**2020 CMOM Package 3 (Applewhite)  
Solicitation Number: CO-00548  
Job No.: 20-4519**

**ADDENDUM 1  
August 12, 2022**

**LINE A - PLAN AND PROFILE SHEET STA 21+00 TO STA 25+00**

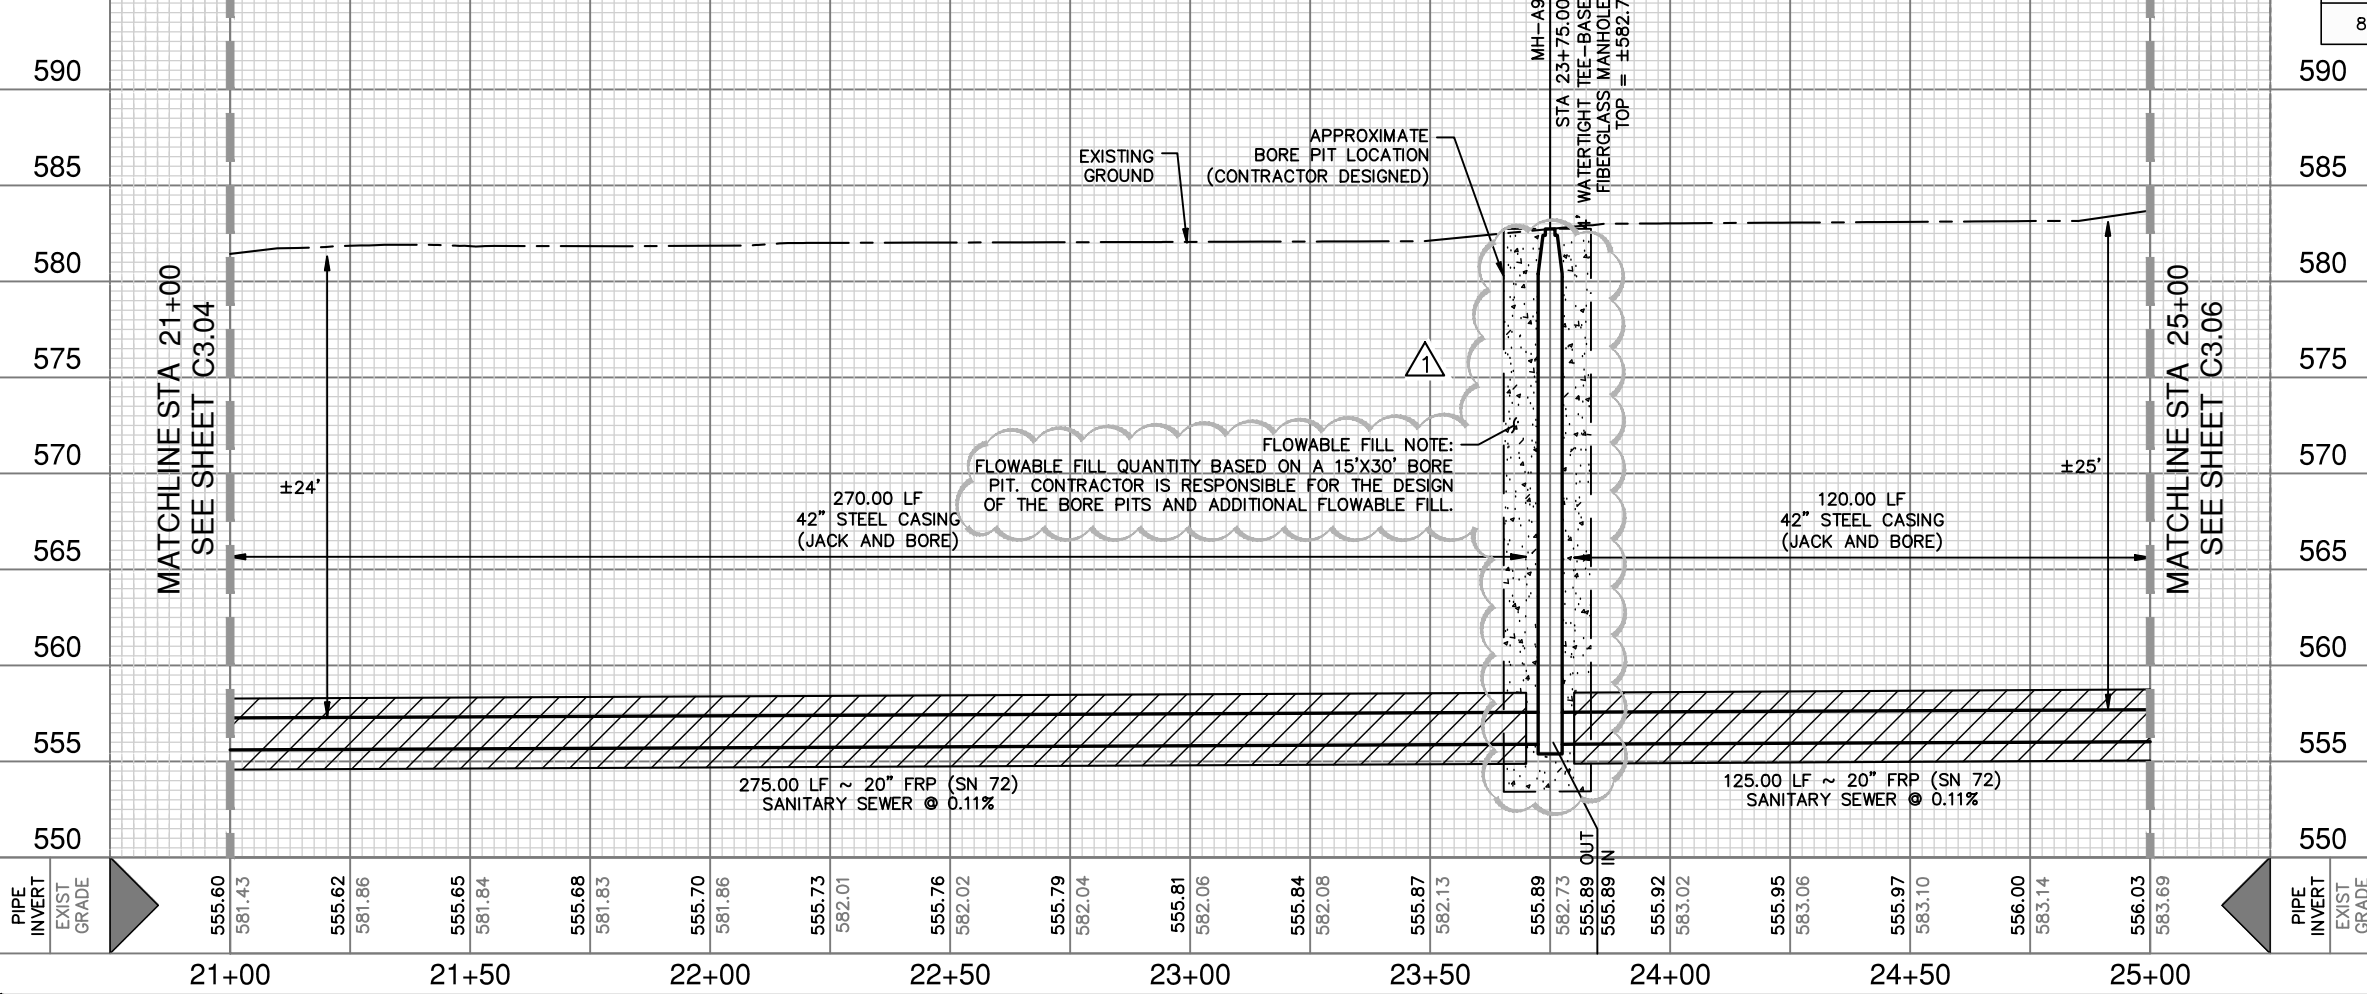
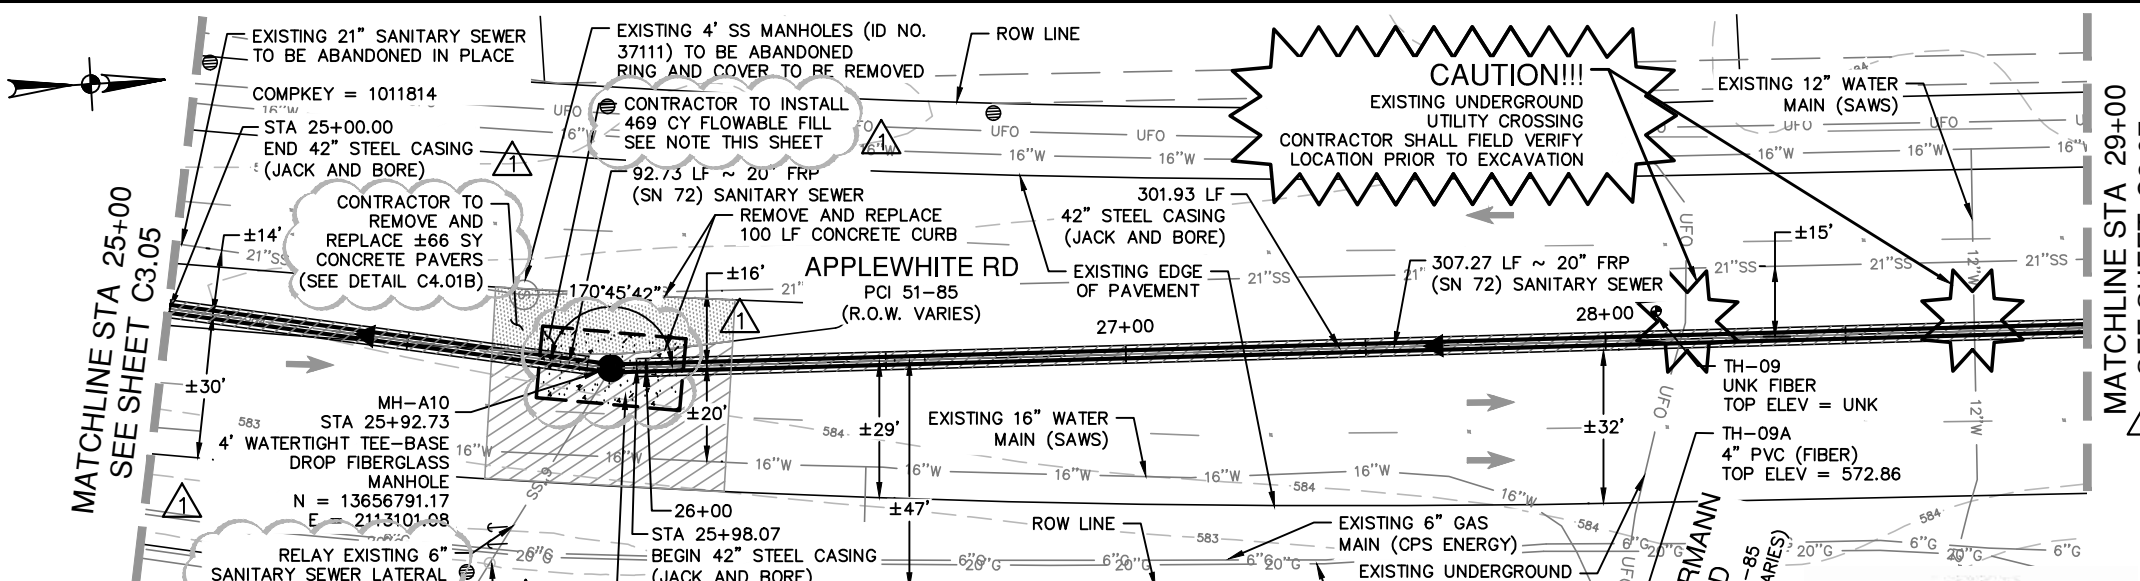
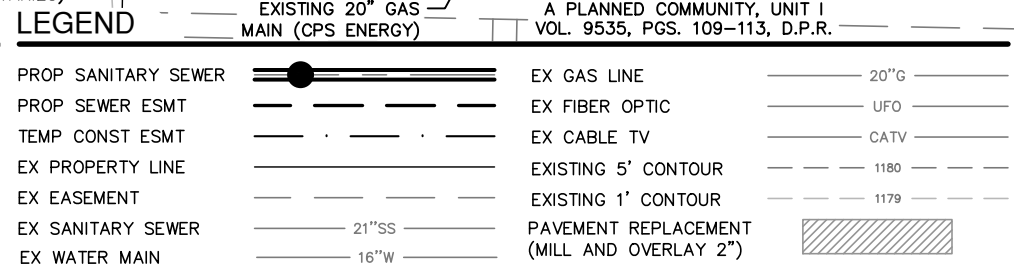
- 3. For the bore pits being on the road and so close to the existing sewer line, can you provide flowable fill backfill bid item. It will be difficult to compact after installation of manhole and with those depths the existing pavement will cave in if you try to compact the bore pits.**  
*Additional flowable fill has been added to the plans and quantities to account for backfilling of the proposed bore pits on sheet C3.04, C3.05, C3.06, C3.07, and C3.08.*

5. Sheet C3.05: Line A – Plan and Profile Sheet Sta 21+00 to Sta 25+00 – Remove in its entirety and replace with the attached document.
  - Added Flowable Fill quantity and note

**2020 CMOM PACKAGE 3 (APPLEWHITE)**  
**LINE A - PLAN AND PROFILE SHEET**  
**STA 25+00 TO STA 29+00**

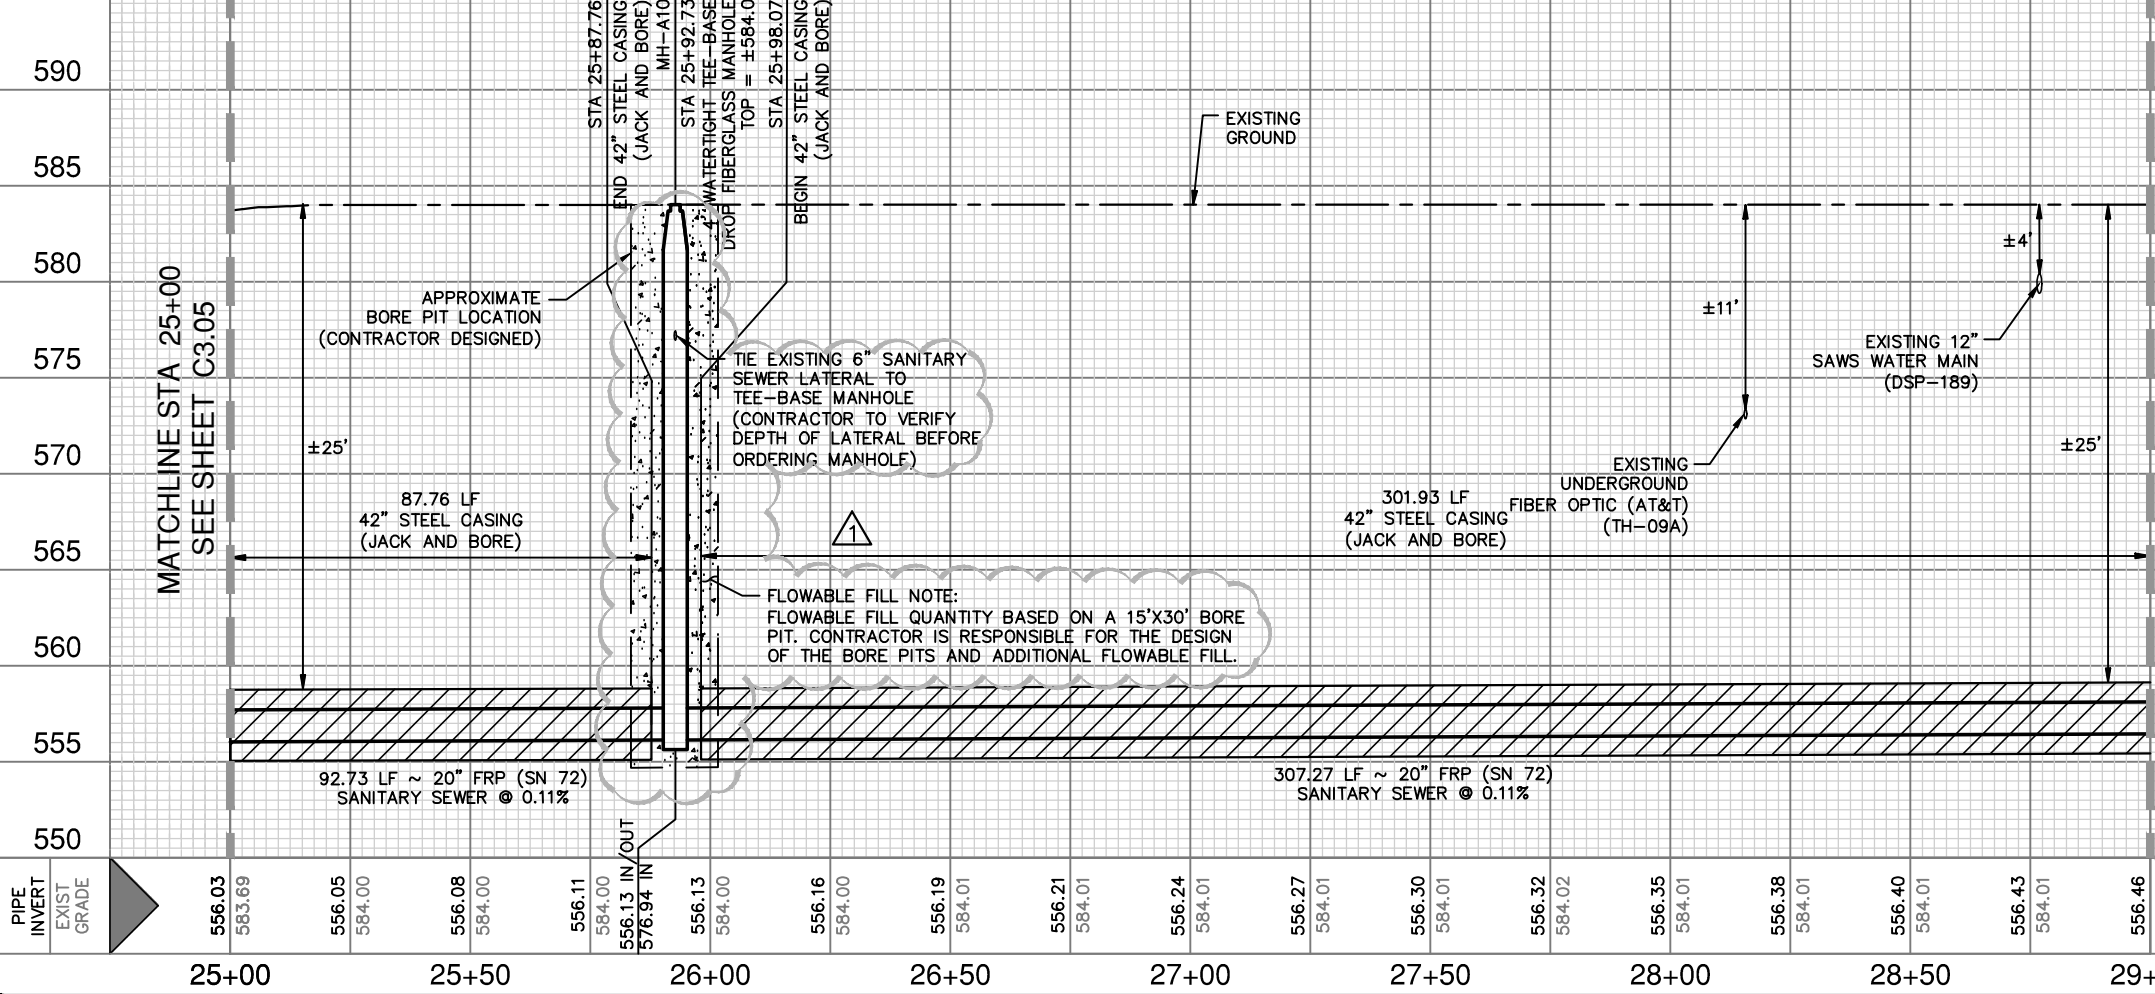
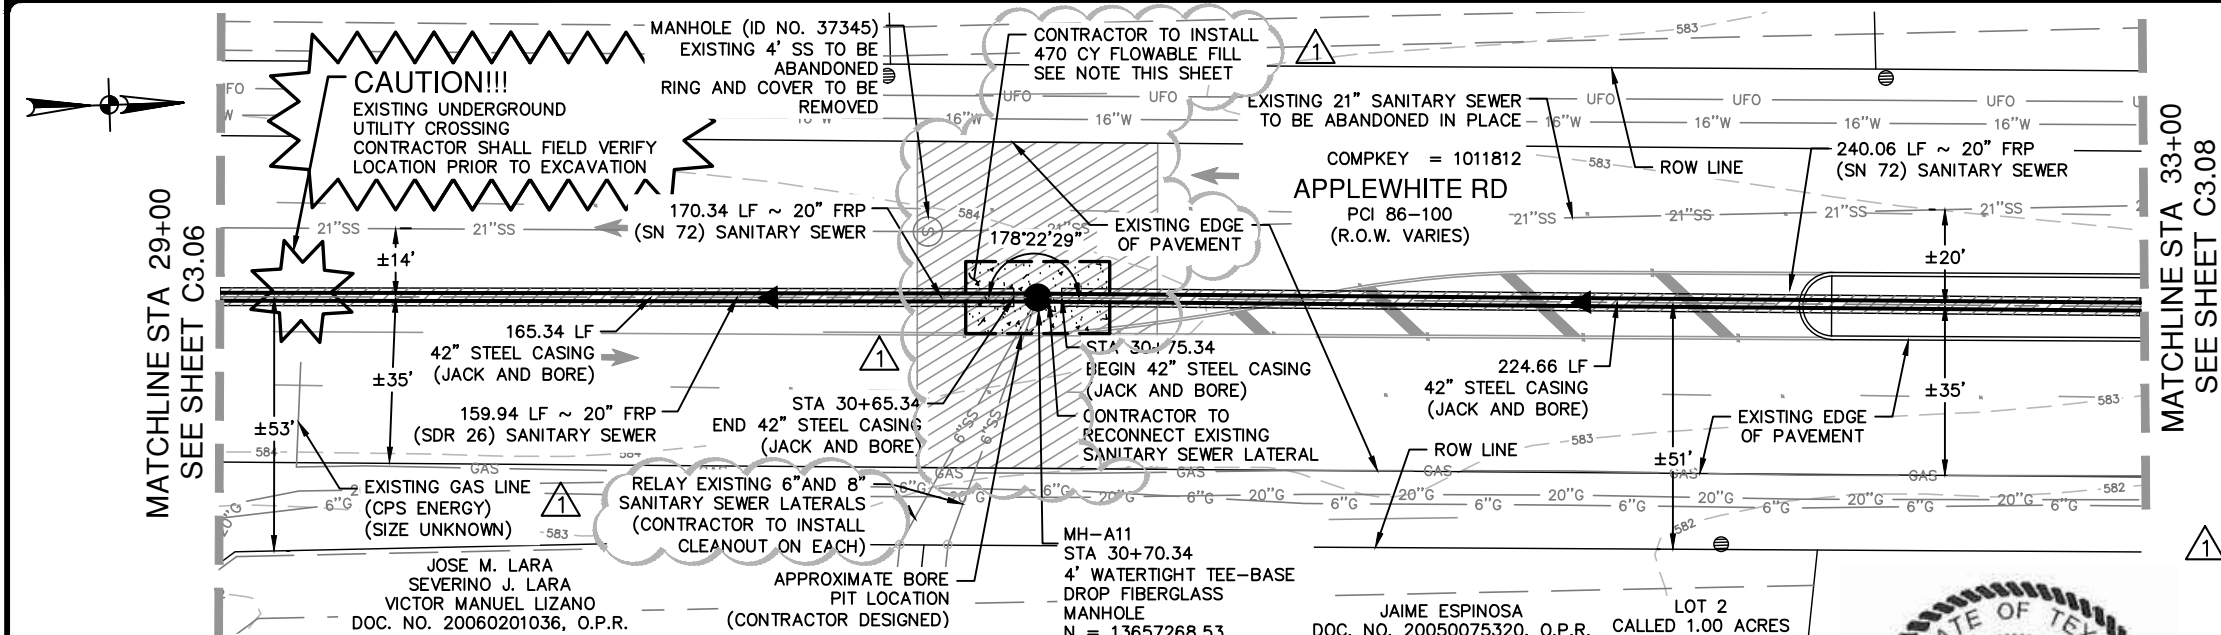
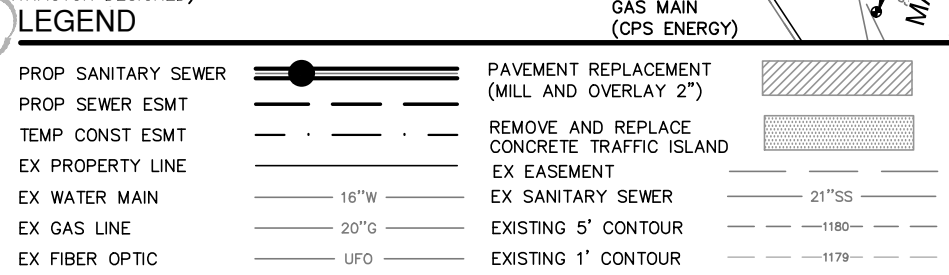
6. Sheet C3.06: Line A – Plan and Profile Sheet Sta 25+00 to Sta 29+00 – Remove in its entirety and replace with the attached document.
  - Added Flowable Fill quantity and note, removed Open Cut Lateral Reconnection Quantity, added Two-way Sanitary Sewer Cleanout and Sanitary Sewer Lateral 6” quantity, revised concrete paver callout
